CITY OF ALBUQUERQUE

May 15, 2024

**RE: Quik Trip Store #7001
521 Unser Blvd NW
Conceptual Grading & Drainage Plans
Engineer's Stamp Date: No Date
Hydrology File: K10D071**

Based upon the information provided in your submittal received 05/02/2024, the Conceptual Grading & Drainage Plans **are not** approved for action by the Development Facilitation Team (DFT) on Site Plan for Building Permit. The following comments need to be addressed for approval of the above referenced project:

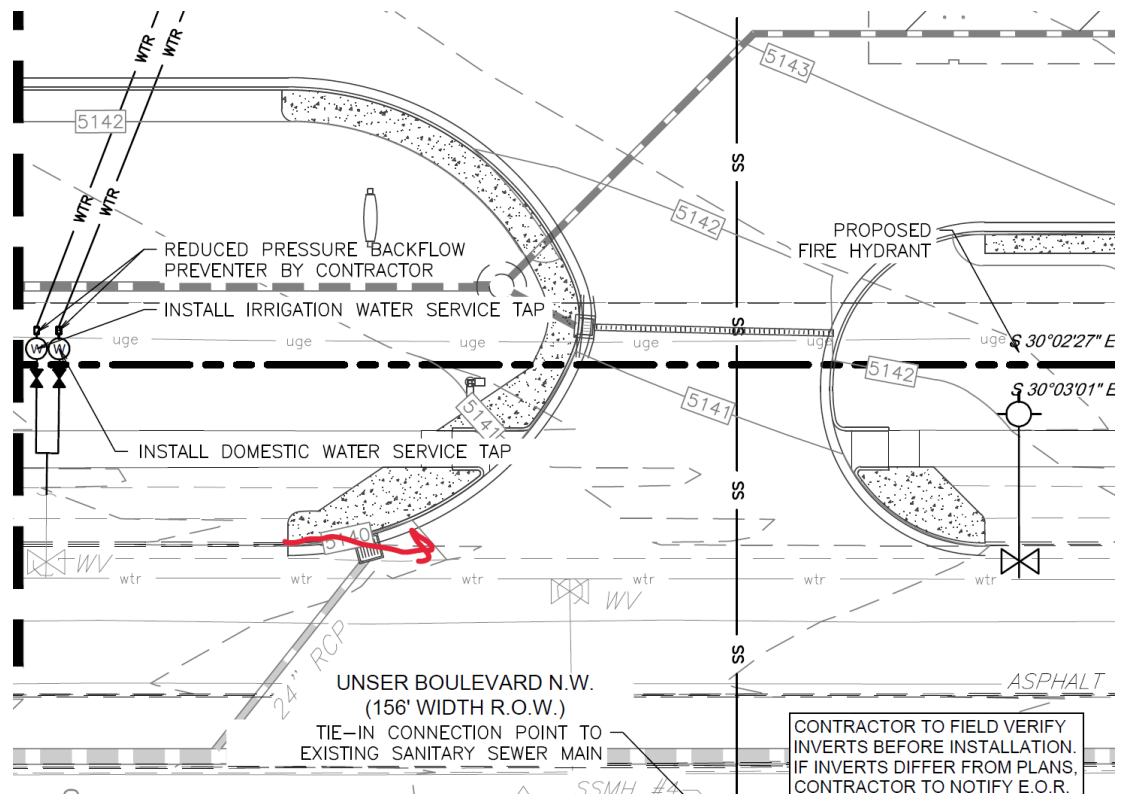
Then in 2006, Jeff Mortensen & Associated revised this areas drainage so that now a portion of this projects site will drain to Unser Blvd and a portion is to drain to an existing detention pond. However, this revised drainage plan only took this project's site as native vegetative (Type A land type per the City's DPM). It also stated that if this track was to be developed, then the detention pond would have to be resize to handle the developed condition of the site.

It is up to you to either just follow the original Master Drainage Plan that has the allowable rate to Unser's storm drain system or revise the existing detention pond to handle this site's developed conditions.

SHEET TITLE:
GRADING PLAN NORTH

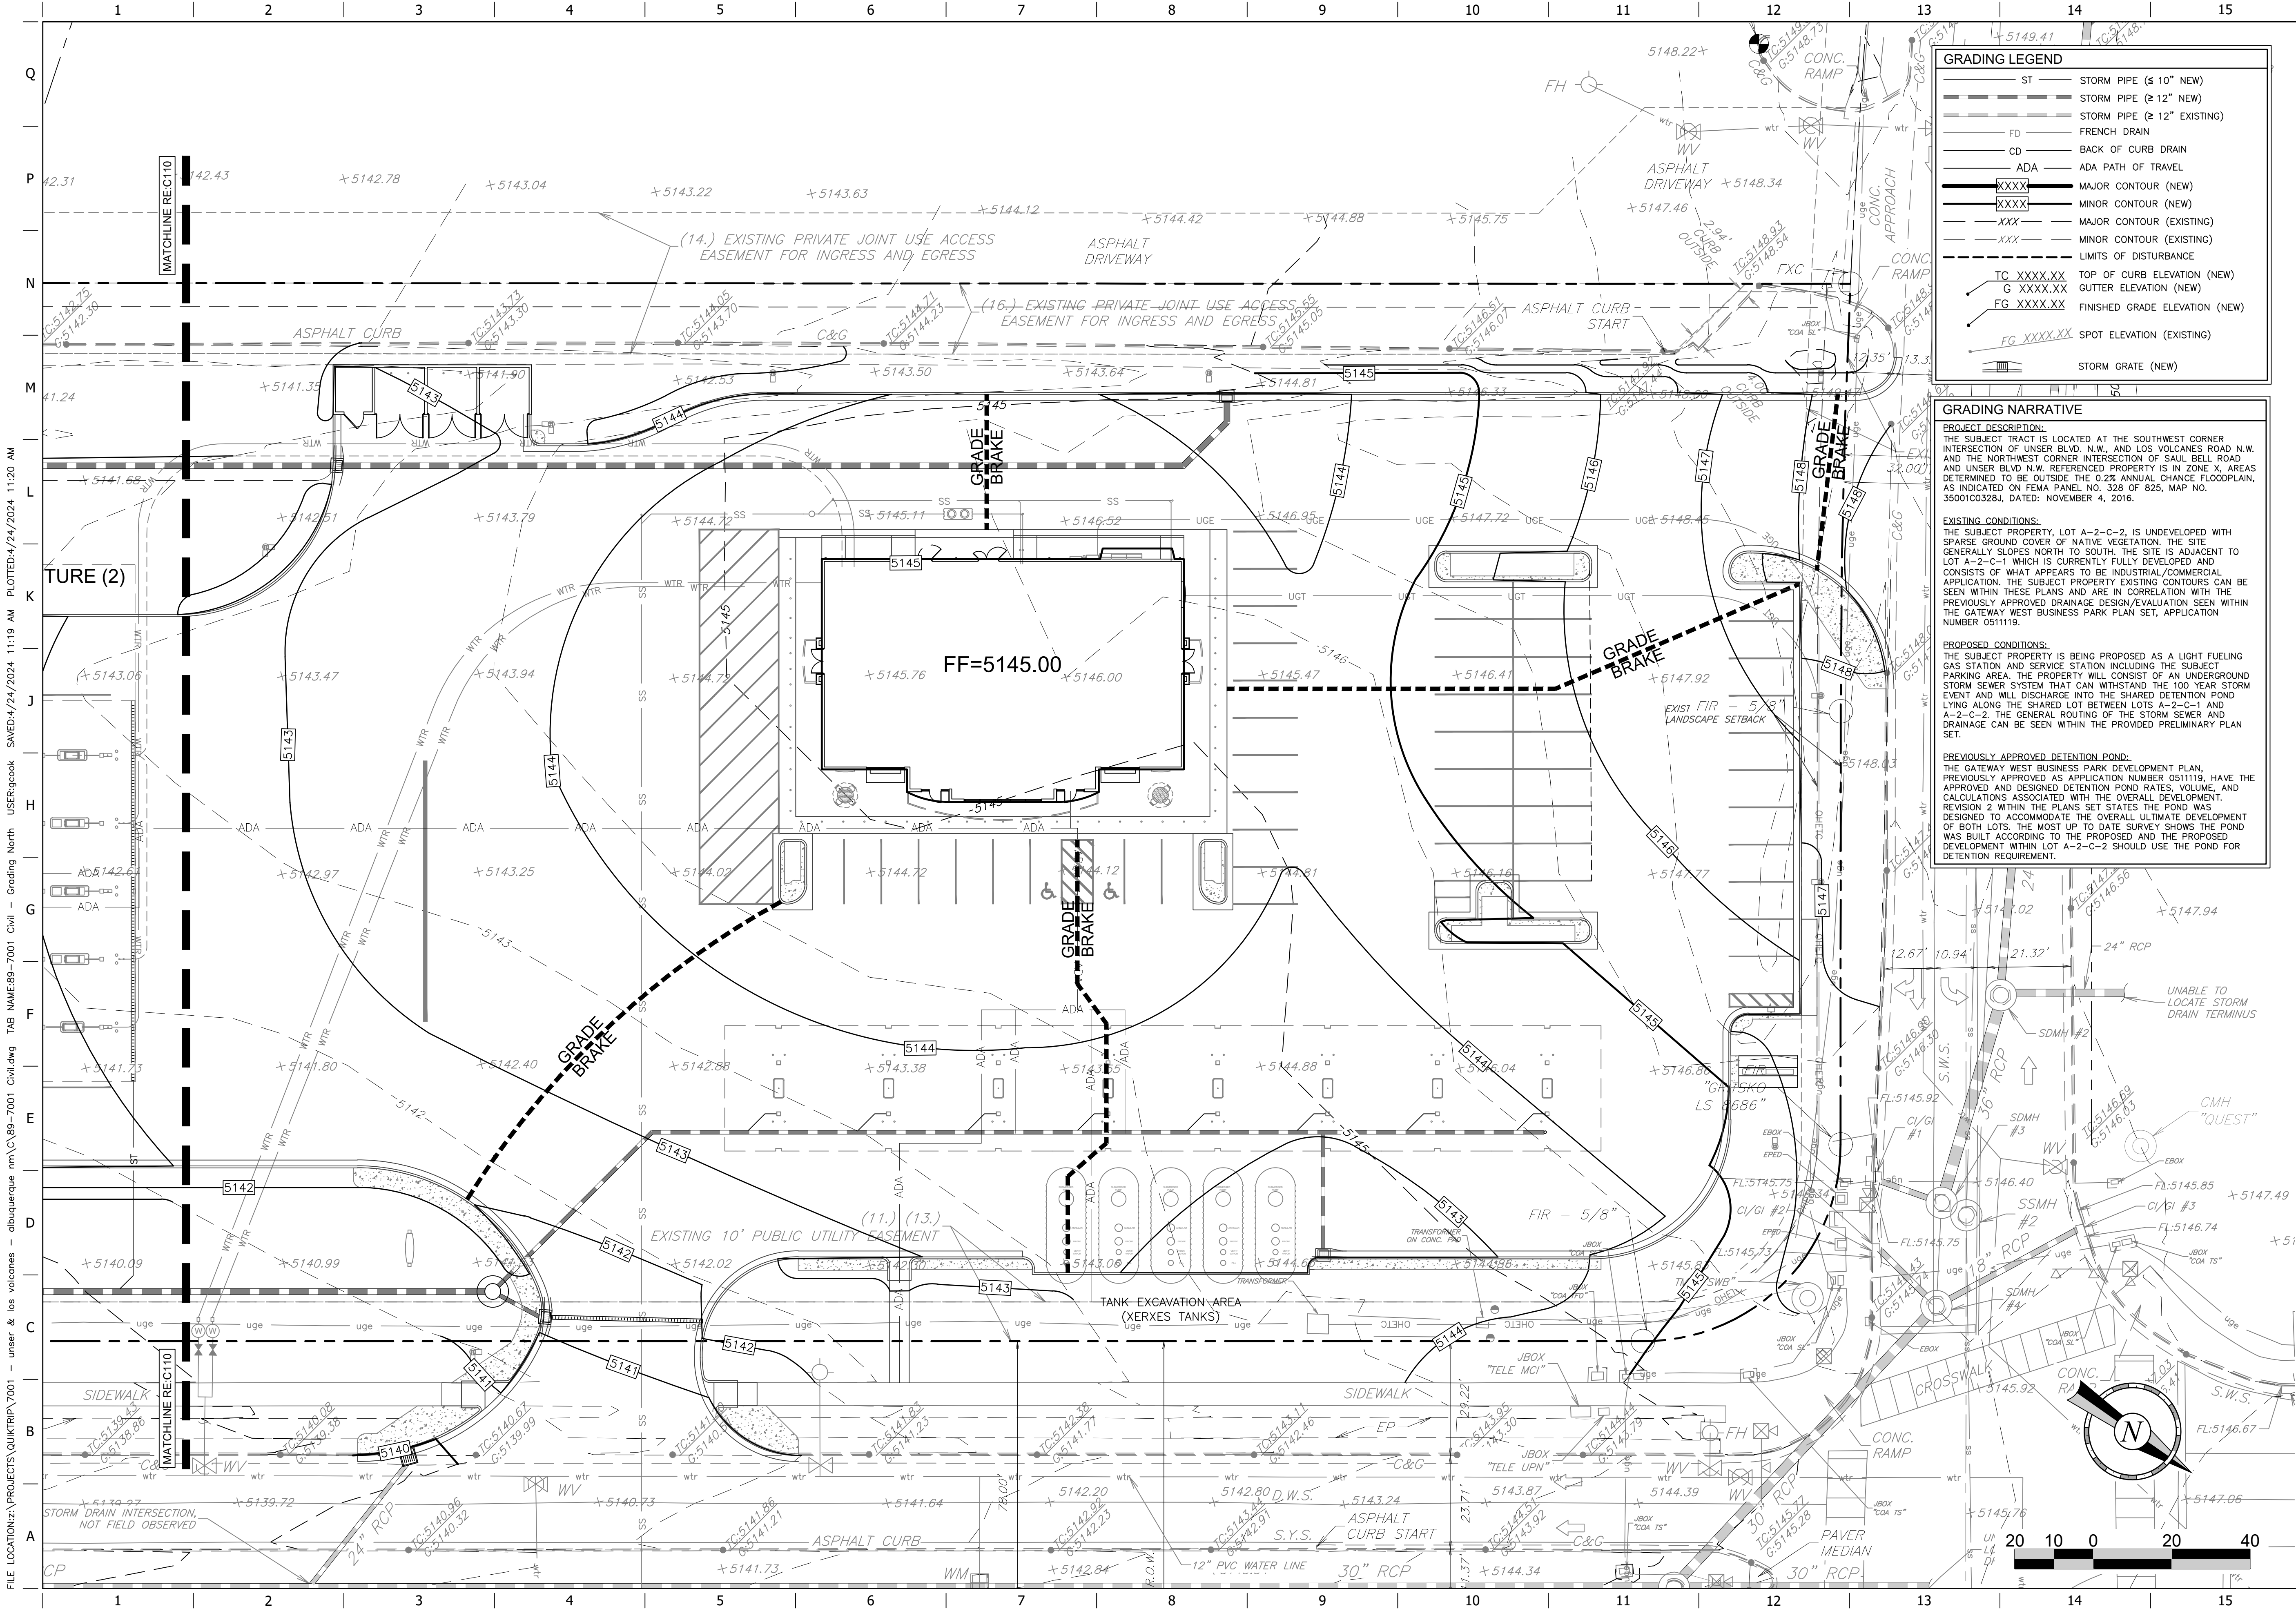
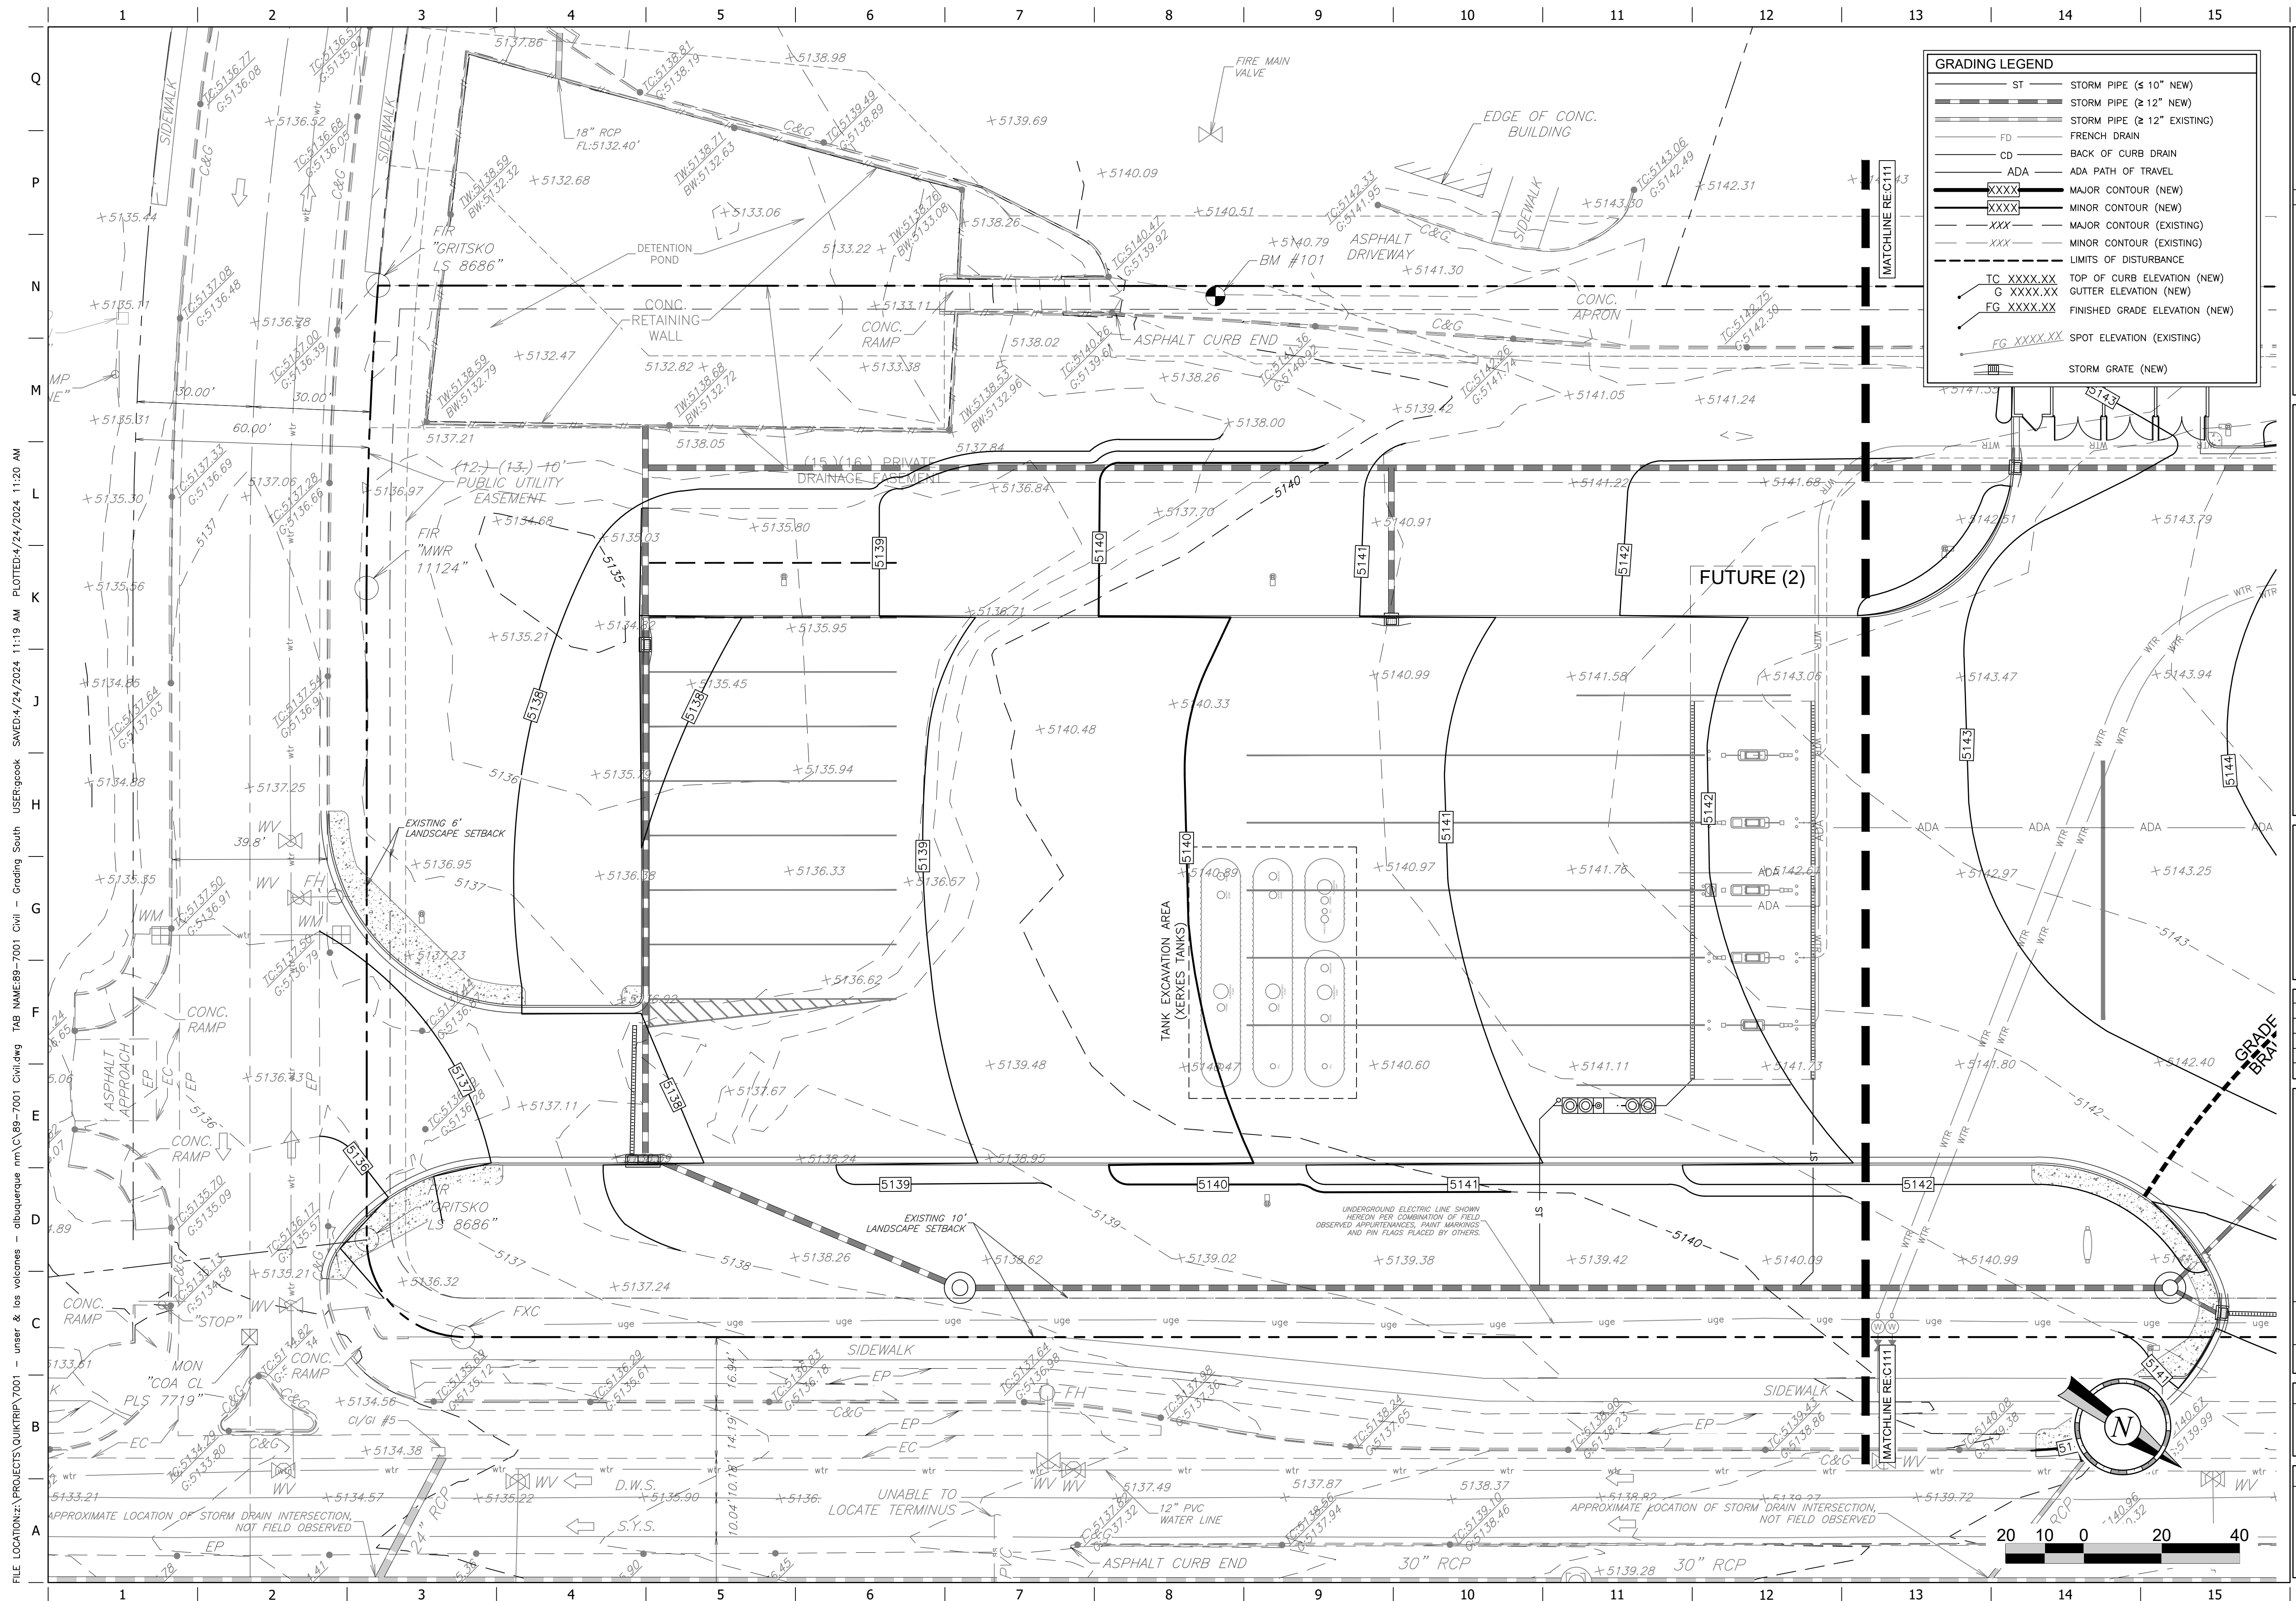
1. Most of this information was provided on the Cover Sheet. However, per the DPM the following must be on the Grading Plan. Please note the Grading Plan must be a stand-alone construction document.

- a. Please provide a Vicinity Map. Typically, this is the Zone Atlas. This can be downloaded in pdf format from the City of Albuquerque's website.
 - b. Please provide the Benchmark information (location, description and elevation) for the survey contour information provided.

- c. Please provide the FIRM Map and flood plain note with effective date.
 - d. Please provide a legal Description of the property.
2. Please use the procedure for 40 acre and smaller basins as outlined in Development Process Manual (DPM) Article 6-2(a). Please provide both the existing conditions and proposed conditions for the 100 year-6 hour storm event.

5. Please number the ponds and include a label on each with the SWQV and elevation, the 100-year volume and elevation, the peak 100-year inflow and outflow, the spillway crest elevation, the spillway flow depth, and the dam top elevation.

6. All gas stations must drain to an oil/water separator (the Owner's choice) prior to discharge. This is mainly for the area around the pumps so some previous stations have placed this prior the remainder of the runoff going into the Stormwater quality pond. Since this site appears to be collected in a pipe system, instead of a manhole, this can be an oil/water separator.

7. Please include the proposed pipe sizes on the Conceptual Grading & Drainage Plans.
8. There is an existing inlet at the driveway location. The entrance needs to be shifted over about 15 feet to ensure that the back of curb radius is tangent at the inlet's transition section.
